PLANT AUDIT REPORT

PLANT AUDIT PERFORMED FOR:			
PLACE:			
CONTACT:			
DATE OF AUDIT:	Preet Mijar & David Hewitson		
TYPE OF MATERIAL PROCESSED:		ESTIMATED ANNUAL TONNAGES:	1,500,000 TPA

#3

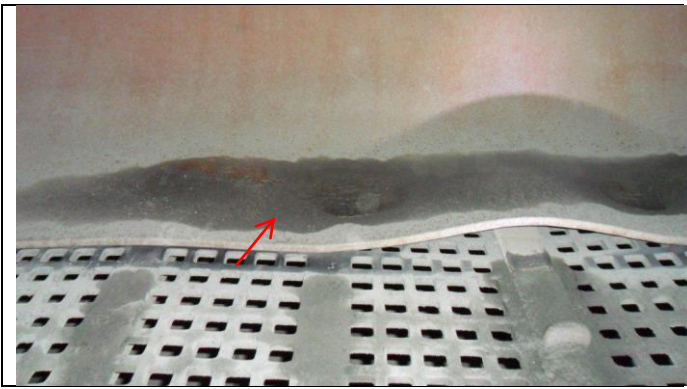
Observation: *Sign of over-tensioning which could lead to premature failure through tearing of fabric plies or screen cloth pulling out of hooks*

Solution: Check side clamping bars are correct profile and over-hook dimensions are correct.

Ensure good crown and support bar capping rubbers are of the same profile

#5

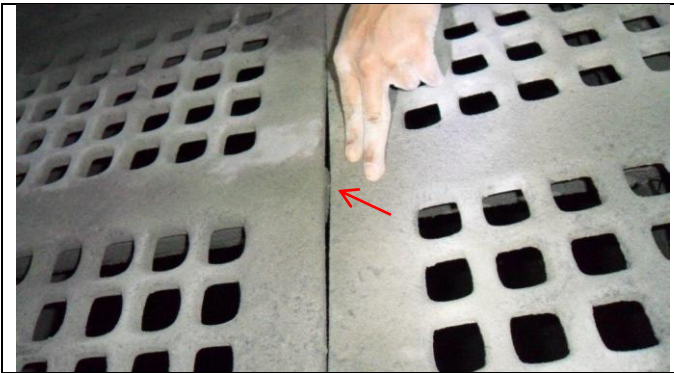
Observation: Support bar capping rubber worn making it impossible to tension the screen cloth. This condition will result in premature screen cloth failure and poor screening efficiency

Solution: It is a good maintenance practice and cheap insurance to always fit new support bar capping rubbers when installing any new screen cloth

#6

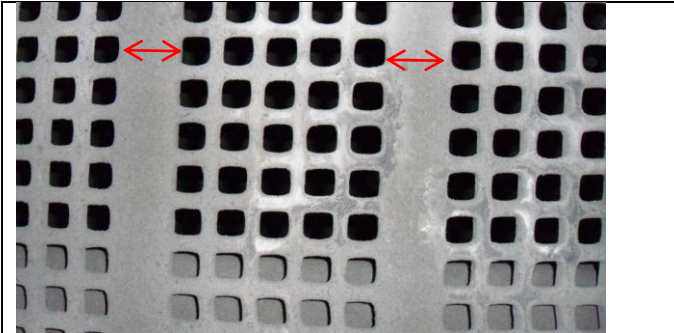
Observation: Simple design – lost screening efficiency and wear life

Solution: Redesign maximising open area by using staggered aperture arrangement

#7

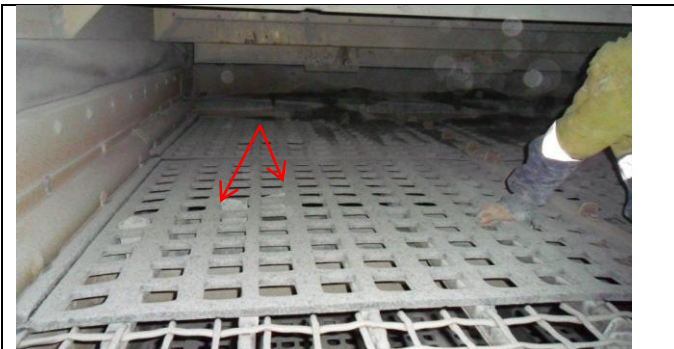
Observation: Poor screen cloth design

Solution: Use off-set aperture arrangement and or redesign for easier installation

#8

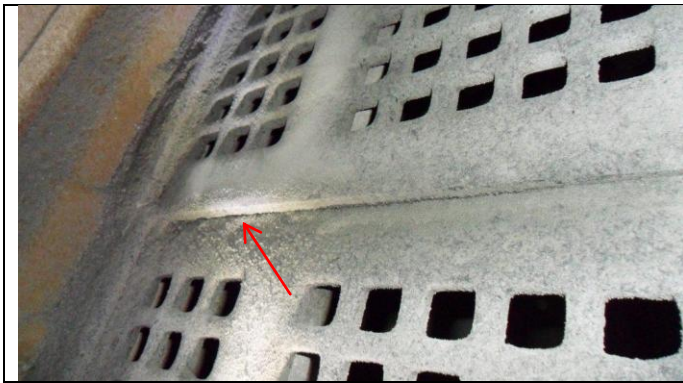
Observation: Screen cloths not sitting evenly on the support bars

Solution: Check side clamping bars are correct profile and over-hook dimensions are correct.

Ensure good crown and support bar capping rubbers are of the same profile

#9

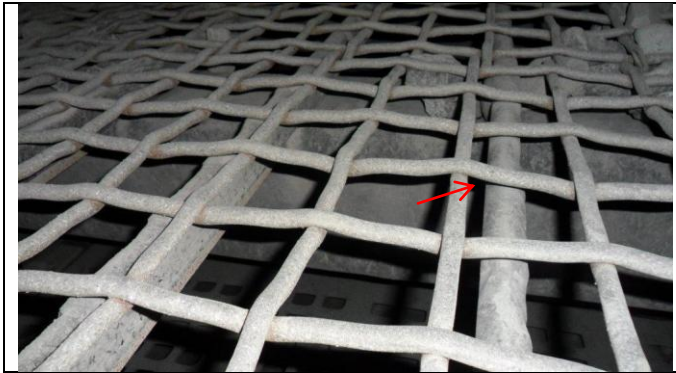
Observation: Pegging. Concentric missing. Side clamps uneven. Very little camber

Solution: Consider self cleaning Flexmats to eliminate pegging and extended wear life.

Check side clamping bars are correct profile and over-hook dimensions are correct. Notice 2 different type of clamps.

Ensure good crown and support bar capping rubbers are of the same profile

#13

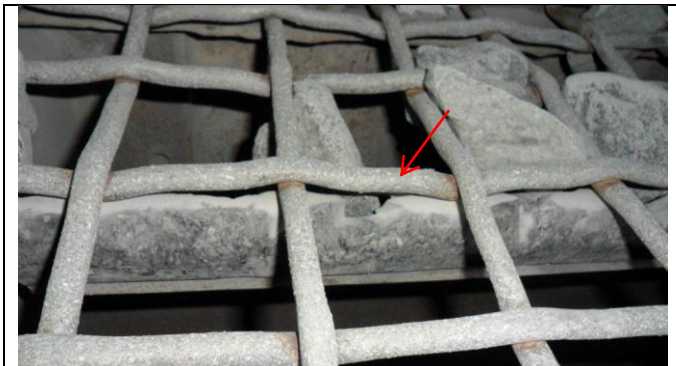
Observation: Differing side clamps, screen cloth hard up against the side wall. Screen cloth not sitting on side support rail. Concentric missing

Solution: Re-fit concentrics

Check side clamping bars are correct profile and over-hook dimensions are correct.

Ensure good crown and support bar capping rubbers are of the same profile

#16

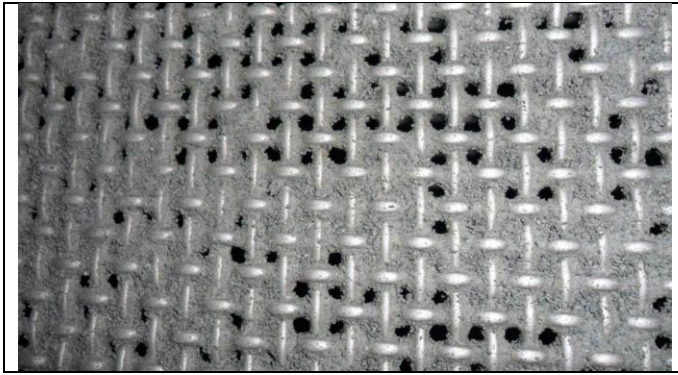
Observation: Side hooks not sitting on side support rails

Solution: Re-fit concentrics

Check side clamping bars are correct profile and over-hook dimensions are correct.
